Arup was engaged by Willoughby City Council to undertake a review of the traffic assessment supporting the proposed modification to the approved concept plan for the Channel 9 campus at 6-30 Artarmon Road, Willoughby. Key findings arising from the review are as follows:

Figure 6 Adjacent developments considered in traffic modelling

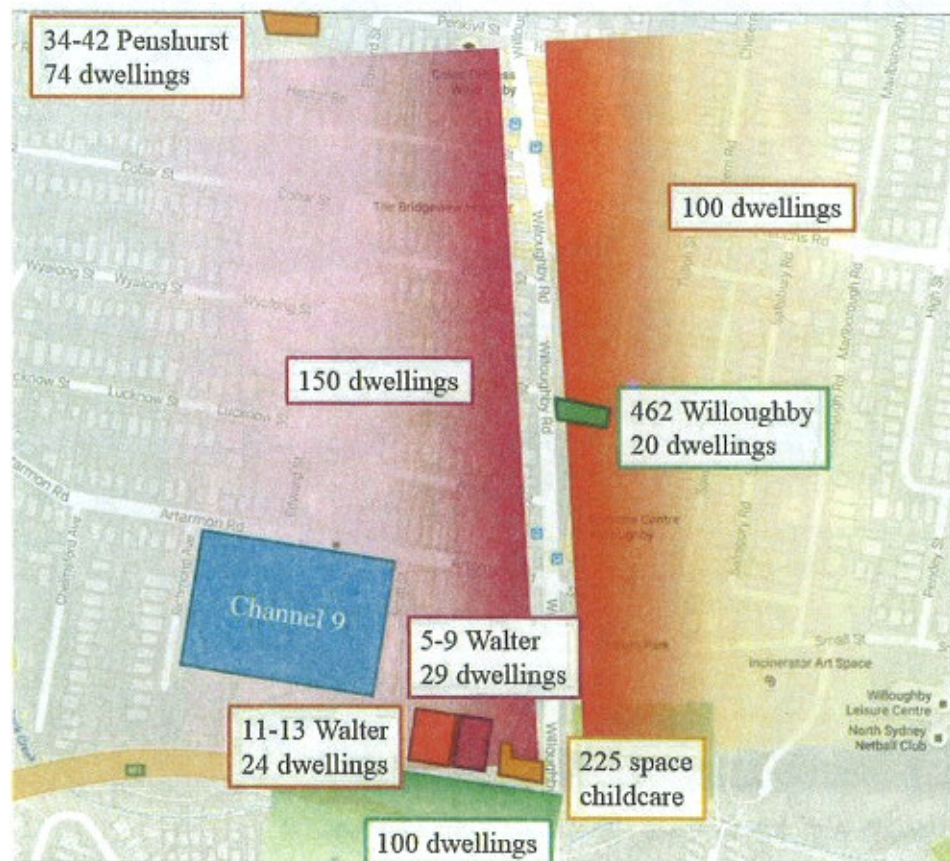
The traffic modelling undertaken for this study has considered the impact of known and potential future developments in the vicinity of the site, based on advice from Willoughby City Council. These are illustrated in Figure 6, and include:

It should be noted that no additional development was considered in the modelling undertaken by GTA consultants to support the concept plan modification.

Figure 8 Forecast queue lengths on Artarmon Road

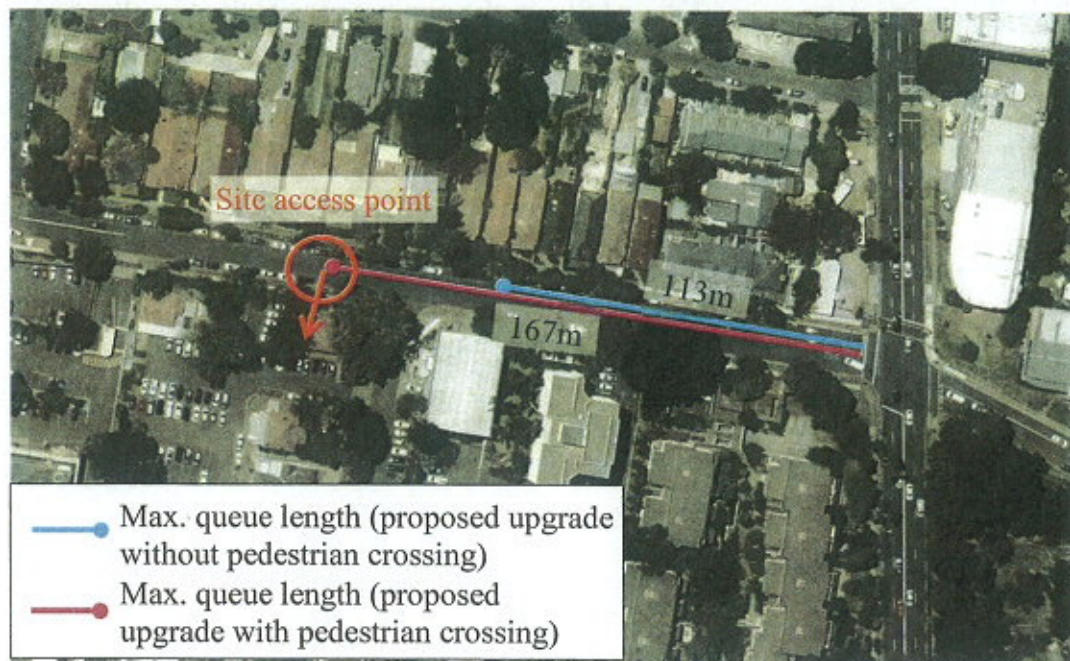
The traffic modelling indicates that when the additional pedestrian crossing is added to the southern approach of the intersection, the intersection operates above it's operating capacity during the Saturday peak hour. Vehicles experience increased delays and queue lengths on Artarmon Road – with queues forecast to extend back nearly 170m.

The forecast change in forecast queue lengths on Artarmon Road between the scenarios considered are illustrated in Figure 8 below. This illustrates that should the intersection upgrade proceed as per the applicant's proposal, queue lengths on Artarmon Road are expected to extend back to the site access point (roundabout) 40m west of Scott Street. However, should a pedestrian crossing on the southern approach of the intersection be provided (as RMS generally require), queue lengths extend back nearly 170m on Artarmon Road. This queue length has the potential to impact the ingress and egress of vehicles into and out of the site.
